18 December 2015

Edition 25

AUSTRALIAN NOTICES TO MARINERS

Notices 1340 - 1404

Note for chart Aus 615

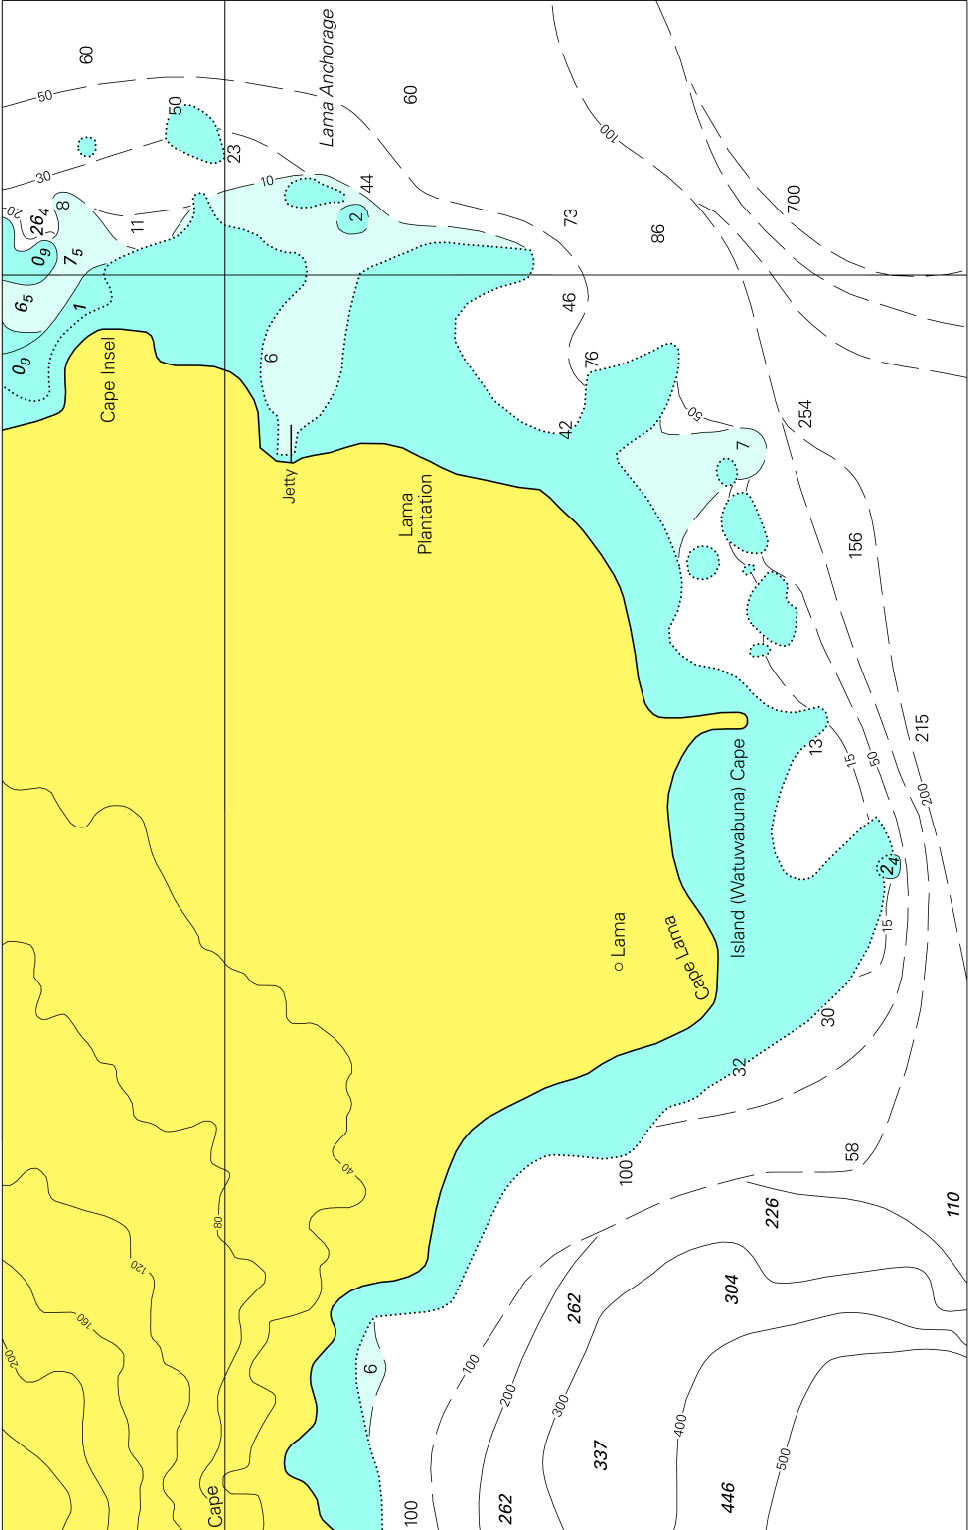
Insert	restricted area limit, between	17° 32'.84 S	148° 05'.00 E
		17° 32'.90 S	148° 05'.14 E
		17° 55'.49 S	148° 16'.26 E
		18° 01'.91 S	148° 23'.34 E
		18° 02'.00 S	148° 23'.81 E
	magenta legend, <i>Area To Be Avoided (see Note)</i> , centred on	17° 38'.0 S	148° 14'.0 E

Insert	restricted area limit, between	16° 25'.38 S	147° 38'.00 E
		16° 18'.56 S	147° 40'.61 E
		16° 18'.00 S	147° 41'.11 E
	magenta dashed line, between	16° 21'.46 S	147° 38'.00 E
		16° 18'.56 S	147° 40'.61 E
	accompanying <i>TWR</i> note	16° 21'.0 S	148° 08'.0 E
	accompanying <i>ATBA</i> note in N border	16° 18'.0 S	148° 00'.0 E
	magenta legend, <i>CORAL SEA TWO-WAY ROUTE (see Note)</i> , centred on	16° 19'.0 S	147° 39'.0 E
	on		
	magenta legend, <i>Area To Be Avoided (see Note)</i> , centred on	16° 27'.0 S	147° 42'.5 E
	magenta legend, <i>Area To Be Avoided (see Note)</i> , centred on	16° 47'.0 S	148° 02'.0 E

Block for Chart Aus 678

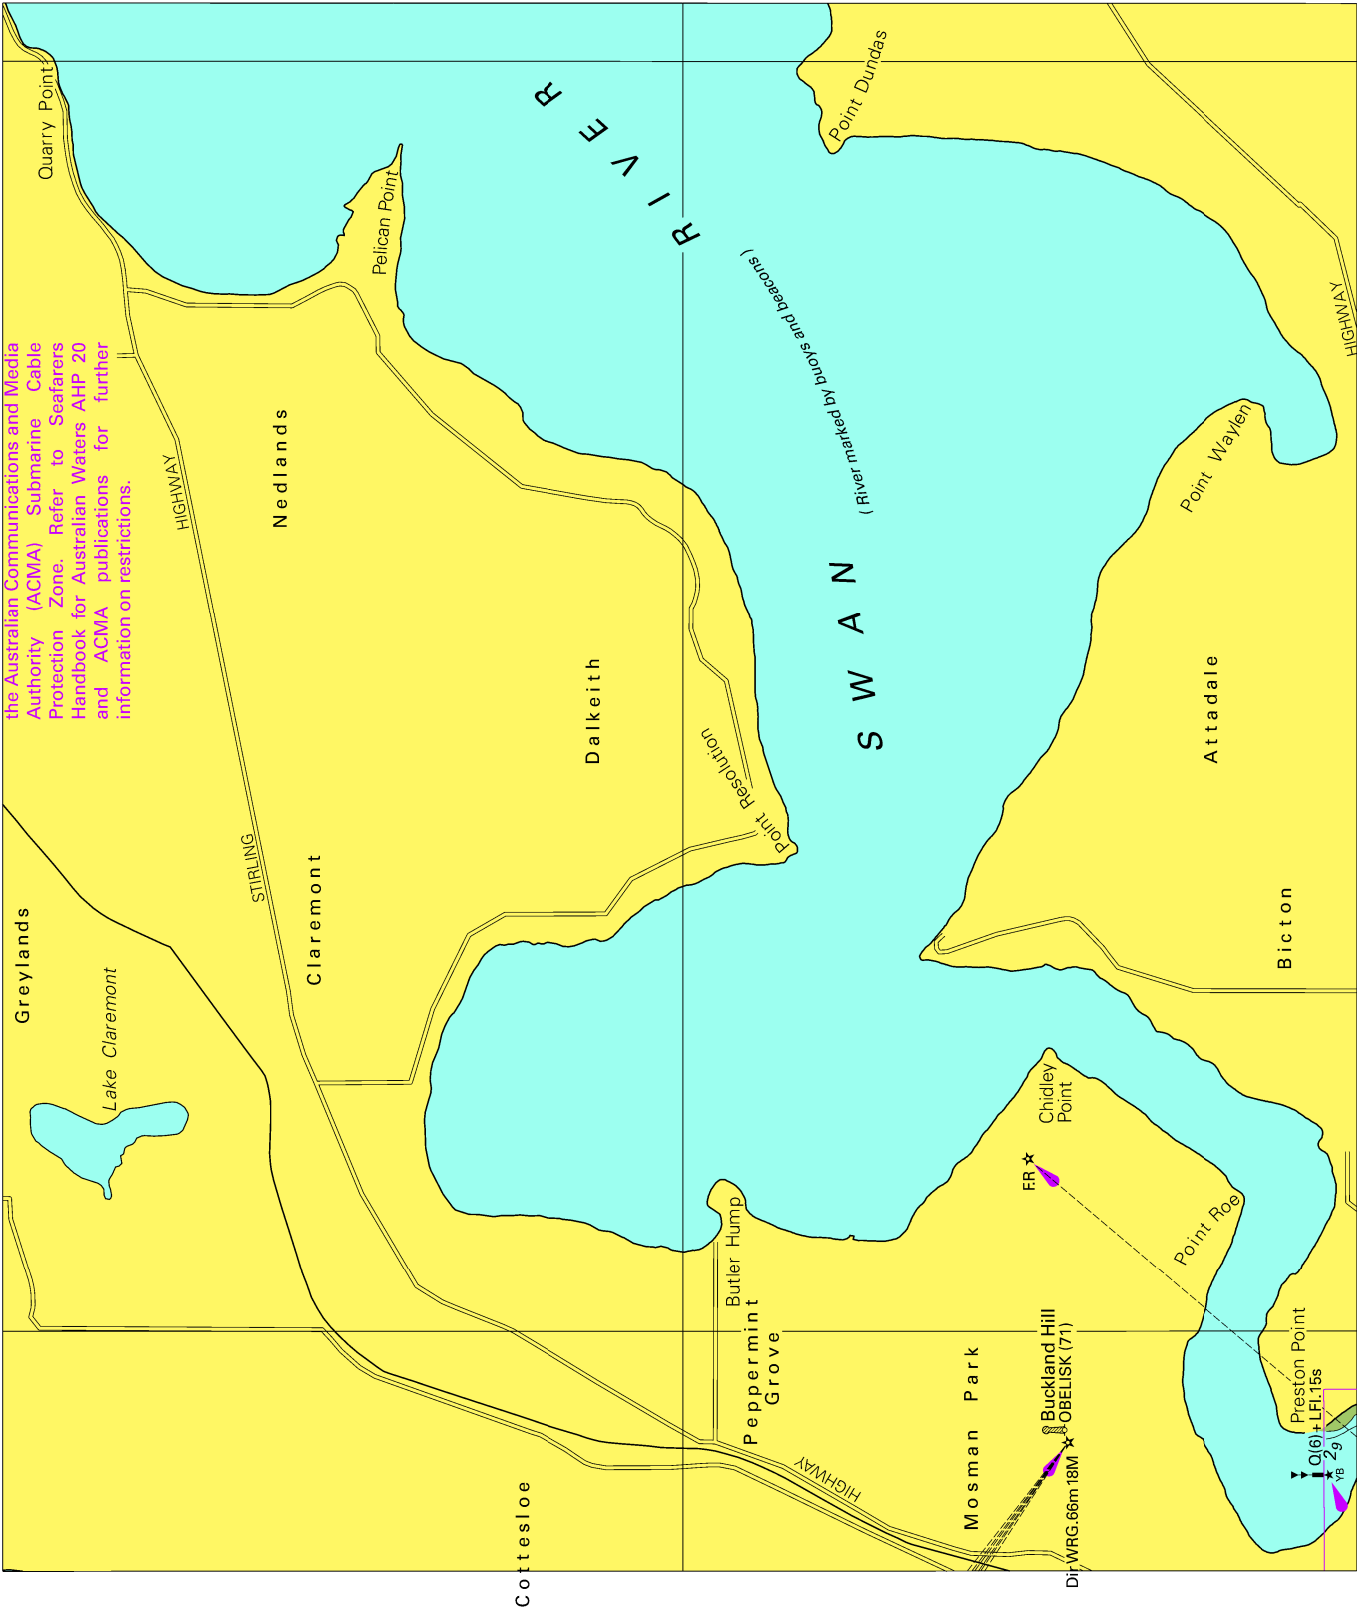
Insert accompanying block

© Commonwealth of Australia 2015
Block for Chart Aus 137 (67.1 x 108.0mm)

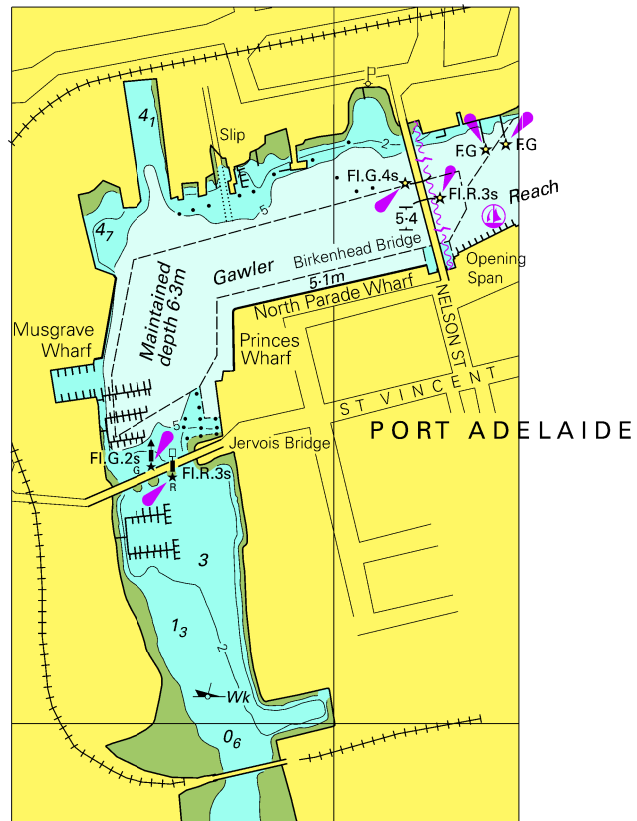
Insert	accompanying block	34° 50'.7 S	138° 29'.9 E
--------	--------------------	-------------	--------------

To accompany Australian Notice to Mariners 1362/2015

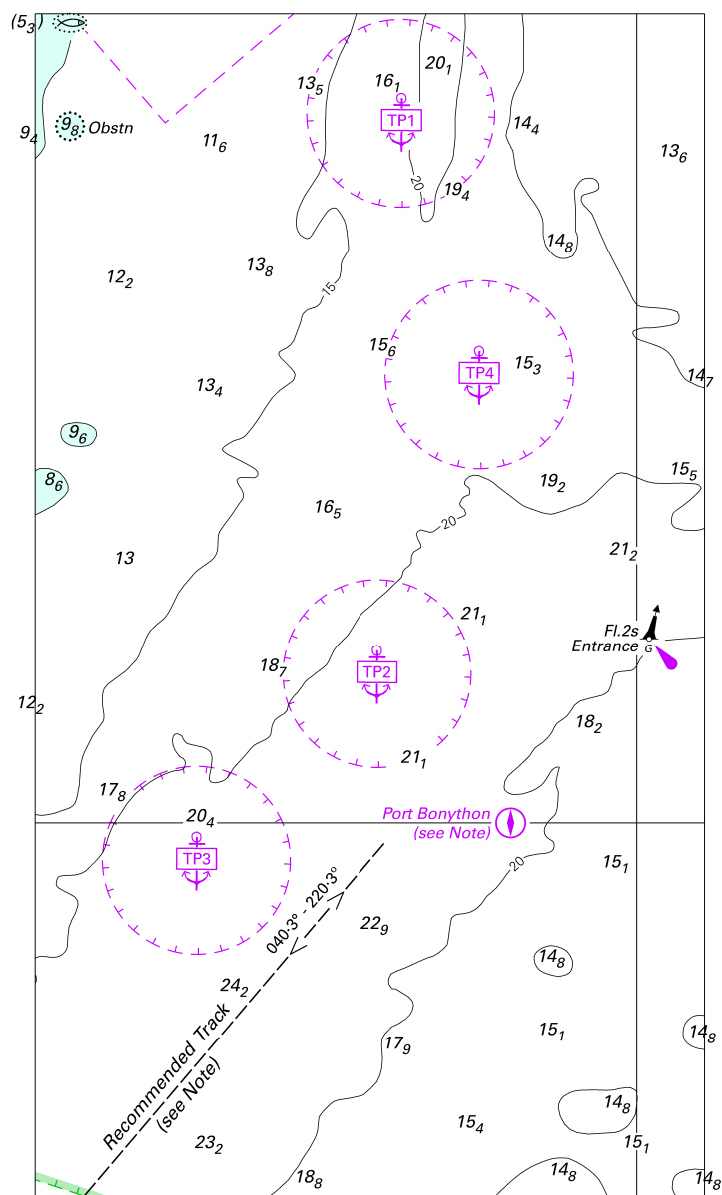
Insert	accompanying block	33° 08'.3 S	137° 38'.0 E
--------	--------------------	-------------	--------------

© Commonwealth of Australia 2015
Block for Chart Aus 778

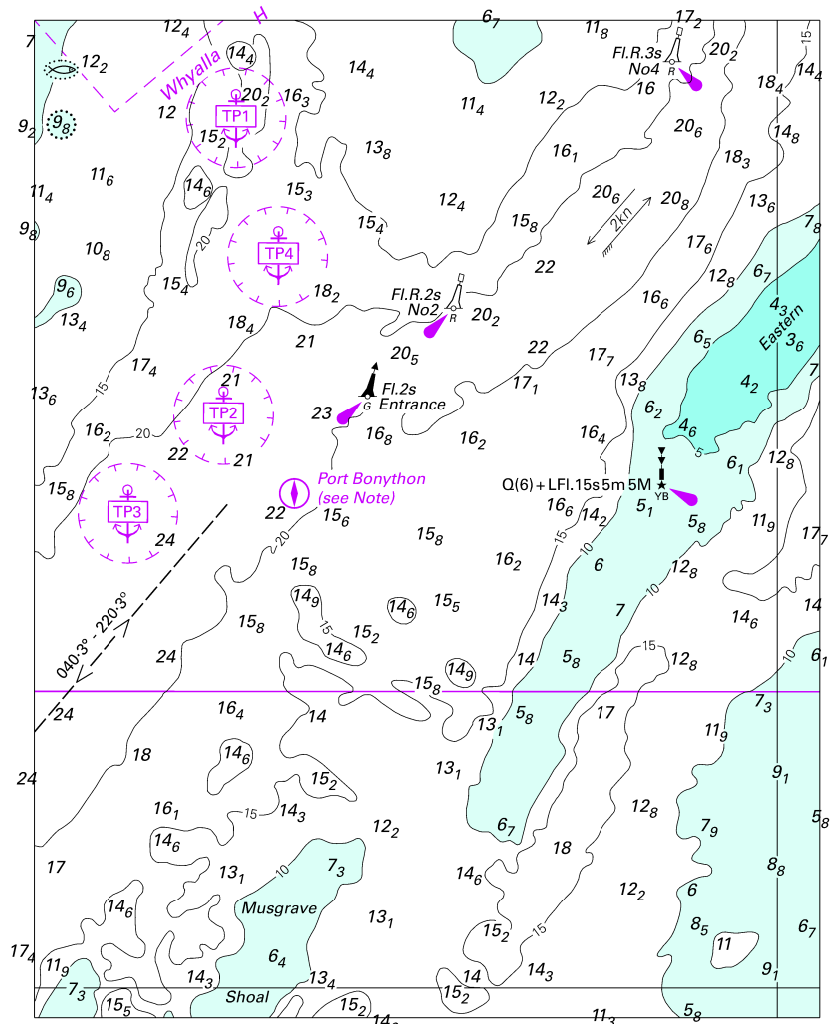
Insert	accompanying block	33° 08'.3 S	137° 38'.0 E
--------	--------------------	-------------	--------------

To accompany Australian Notice to Mariners 1364/2015

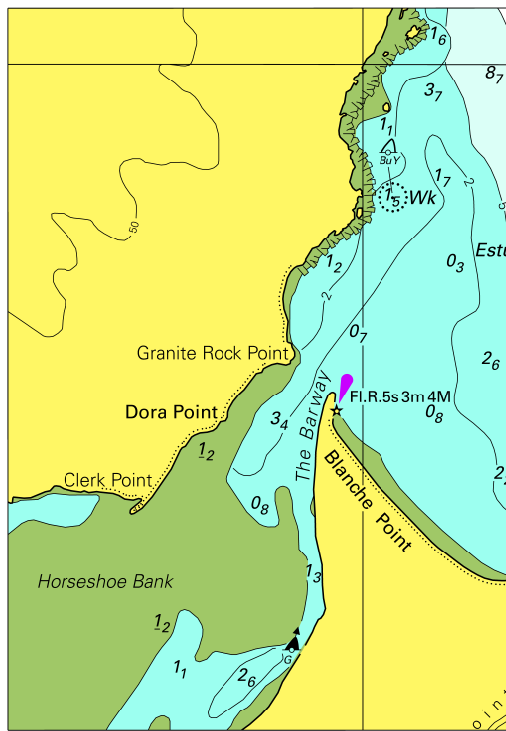
Insert	accompanying block	41° 16'.4 S	148° 20'.0 E
	port lateral cylindrical buoy, No 8A, with topmark	41° 18'.485 S	148° 17'.667 E
Delete	beacon	41° 18'.50 S	148° 17'.65 E
